UNITED STATES PATENT AND TRADEMARK OFFICE

APPLICATION NO.	FILING DATE	FIRST NAMED INVENTOR	ATTORNEY DOCKET NO.	CONFIRMATION NO.
09/828,470	04/06/2001	Richard W. Layne	31752.01 / SP00988.231	6760
46333	7590	08/19/2010		
Medtronic Attn: Noreen C. Johnson, IP Legal Department 2600 Sofamor Danek Drive Memphis, TN 38132			EXAMINER NGUYEN, CAMTU TRAN	
			ART UNIT 3772	PAPER NUMBER
			MAIL DATE 08/19/2010	DELIVERY MODE PAPER

Office Action Summary	Application No. 09/828,470	Applicant(s) LAYNE ET AL.	
	Examiner Camtu T. Nguyen	Art Unit 3772

DETAILED ACTION

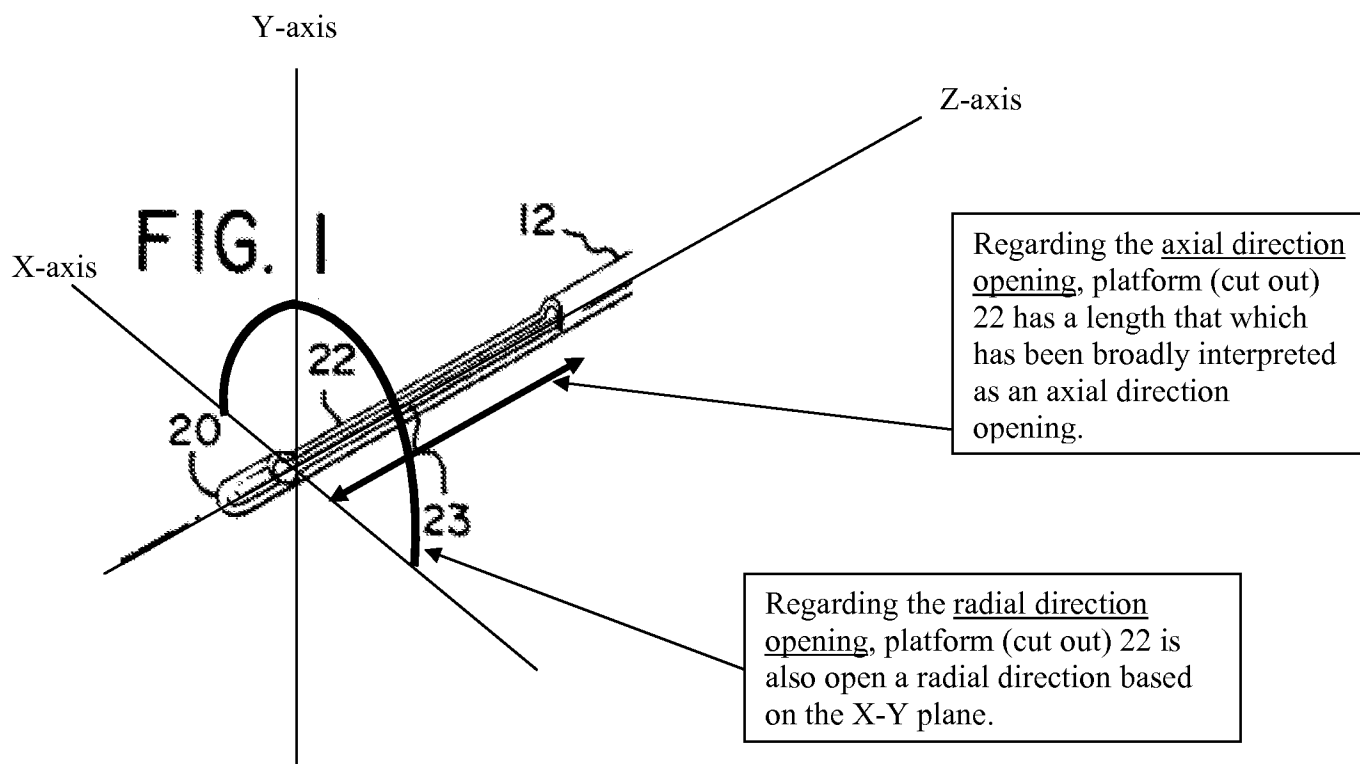
Regarding claim 1 reciting the platform that is open in a radial direction to form a radial direction opening and in axial direction opening, see illustration below.

The interpretation above illustrates the axial direction opening is transverse to the radial direction opening.
